FIELD SERVICE BULLETIN

FSB Number: LVCCFSB2006-137
Authors: Darwin Garcia
Date: May 8, 2006
Total No. of Pages: 2
Subject: **V3 Noisy Knuckle**
Model Affected: **V3**
Level of Repair: 2

K-Flex rubbing in the knuckle

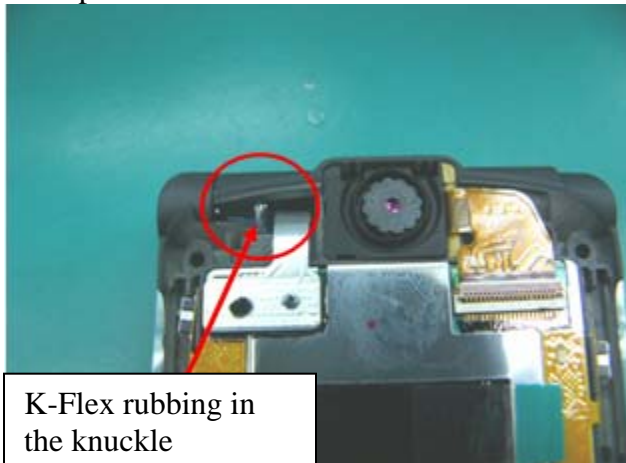
The EMEA service team has reported V3 noisy knuckles issue after K-Flex replacement. This clicking noise can be heard when opening the flip.

The root cause was determined to be the K-Flex rubbing in the knuckle creating this clicking noise; this was due to service center not applying grease to the endcap during repair. The factory assembly procedure calls for grease to be applied to the shaft side endcap.

Grease Placement procedure:

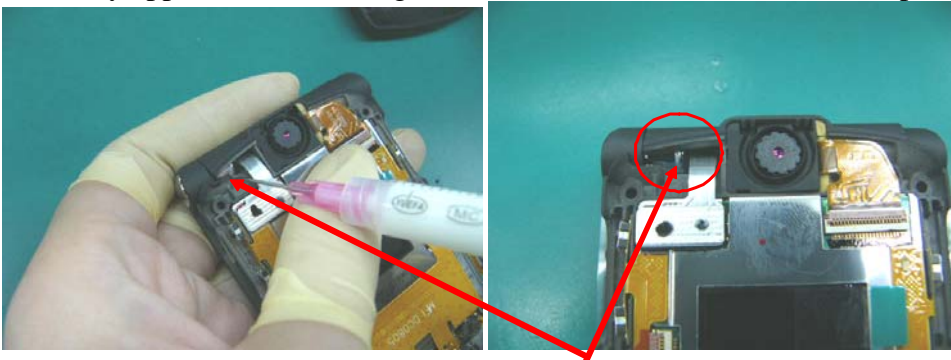
Is recommended that service center add grease to the endcap.

Recommended lubrication is NYE NYOGEL 744.

1. Press 40 pin connector of P-flex into the slot of LCD.

2. Evenly applied 1mm (5~8mg) of the lubricant into the end of endcap shaft.

3. Open and close flip twice to ensure the lubricant is spread.
